Access Compliance Report

Public Rights-of-Way

Intersection ID: 10020275	Main Street: AYRSLEY_TOWN_BV	Cross Street: N/A	Location: NE
ADA ID: 8C404AD9C599	Ramp Type: BlendTrans1	Initial Pass/Fail: Fail	Overall Compliance: No
		Severity Score: 8.75

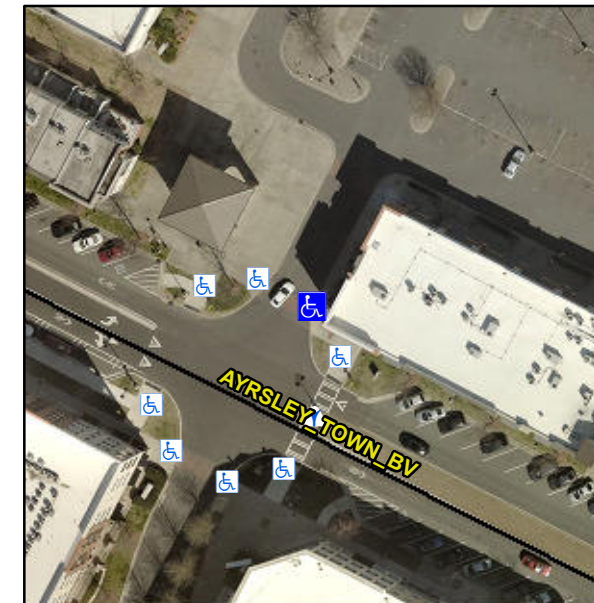
XWALK PAVERS, RESTURANT BENCH WITHIN LT FL

Not Found, R304.5.1

Compliance	Description	Data	Compliance	Description	Data
N/A	Ramp Length (in)	85.0	Yes	BlendTrans Slope (%)	3.4
No	Ramp Width (in)	47.0	Yes	BlendTrans XSlope (%)	2.0
N/A	Flare Type LT	N/A	N/A	Flare Type RT	N/A
N/A	Flare Slope LT (%)	N/A	N/A	Flare Slope RT (%)	N/A
N/A	Flare Traversable LT?	N/A	N/A	Flare Traversable RT?	N/A
N/A	Landing Length (in)	N/A	N/A	DWS Provided?	N/A
N/A	Landing Width (in)	N/A	N/A	DWS Contrast?	N/A
N/A	Landing Slope (%)	N/A	N/A	DWS Length (in)	N/A
N/A	Landing X Slope (%)	N/A	N/A	DWS Full Width?	N/A
N/A	Landing Curb? (Y/N)	N/A	N/A	DWS Offset (in)	N/A
N/A	Shared Landing?	N/A			
N/A	Gutter Ponding?	N/A	N/A	Gutter Slope (%)	N/A
N/A	Gutter Lip Ht (in)	N/A	N/A	Gutter X Slope (%)	N/A
N/A	Painted X Walk1?	No	N/A	Painted X Walk2?	N/A
	X Walk 1 Direction	To W		X Walk 2 Direction	N/A
	X Walk 1 Width (in)	N/A		X Walk 2 Width (in)	N/A
	X Walk 1 Slope (%)	3.5		X Walk 2 Slope (%)	N/A
	X Walk 1 X Slope (%)	1.2		X Walk 2 X Slope (%)	N/A

N/A	Ramp inside XWalk1?	N/A	N/A	Ramp inside XWalk2?	N/A
	Road Slope (%)	1.2		Clear Space?	N/A
	Road X Slope (%)	3.5	N/A	Clear Space to XWalk (in)	N/A
N/A	Any Obstructions?	N/A	N/A	Storm Grate/Utility Hazard?	N/A
	Obstruction Type			Storm Grate/Utility Type	
		N/A			N/A
			Yes	Surface Condition? (G/P)	Good
			No	Curb Slope (%)	18.2

Remove & Replace Curb Ramp With Two New Directional Ramps or Equivalent.
